### MINISTRY OF ENERGY AND MINES

#### REPORT OF GEOTECHNICAL INSPECTOR

Mount Polley Mine

September 13, 2013

Photo 1: Tension Cracks and slump on south west crest of Wight Pit above underground access

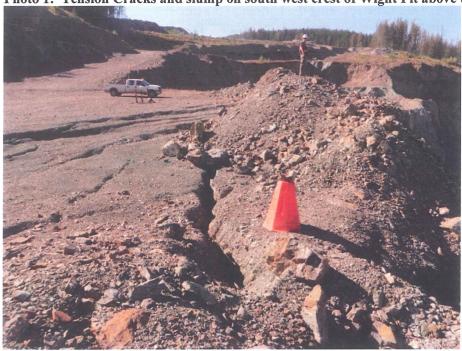
the exception of the installation of 6ft friction bolts in the back. The stability of the Wight Pit and potential impact on underground infrastructure at the base of the pit is a concern that needs to be properly assessed.

Prior to commencing production mining the Mine shall complete a detailed assessment of the Wight Pit slope stability and rockfall hazard to the infrastructure located within the pit. The analysis should consider the effects of blast vibrations from production blasts. Details of pit slope monitoring program and trigger levels shall be included in the report.
